SDP-23-02 / 6000 Rogers Road
2nd Submittal
Planning/Zoning Comments
July 3, 2023

This is the 2nd review of a Site Development Plan [SDP] application, completed by Commercial Site Design, revision dated May 3, 2023. The application proposes to develop a single, non-residential, building containing multiple retail/service/commercial suites, with associated parking, landscaping, utilities, and stormwater facilities on a 2.09-acre lot.

Site Plan (Sheet C.2):

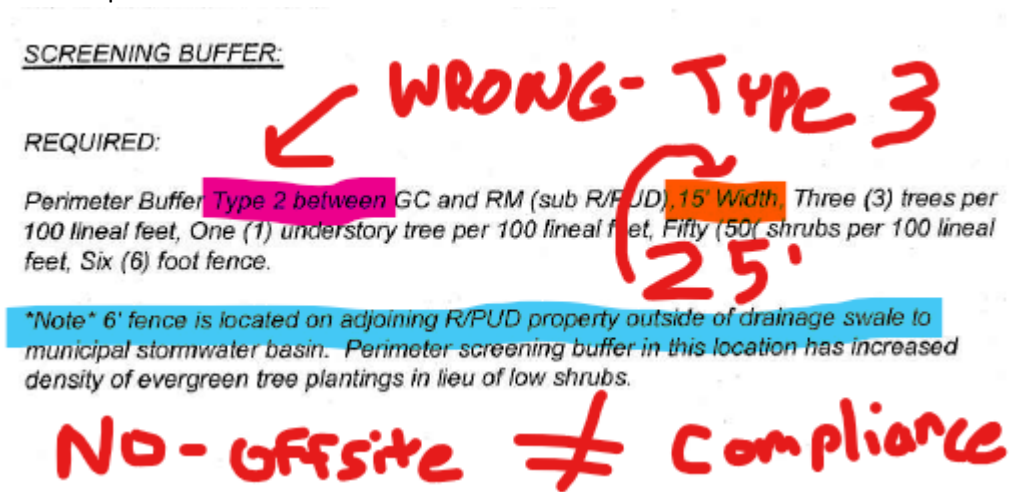
- 13. LDO 6.8.4.B. - Pedestrian Considerations. With the current design of the drive-thru stacking areas, address how Pedestrian access from (PIN 1759715088 to the south) and its sidewalk system are being meshed together/accommodated. Currently, there is no Pedestrian pathway to go from the adjacent sites building to the proposed building, without a circuitous route out to Rogers Road and through this site’s parking lot, back to proposed building. Overall vehicular mobility is highly prioritized over pedestrian options on this site.

- A. See Mark-ups - (particularly in the area shown in the red hatched cloud on the plans). Please reference LDO Section 6.8.4. for the design requirements of pedestrian facilities as they relate to the site, adjacent sidewalk, both building frontages, and pedestrian amenities (Section 6.8.4.B.2.)
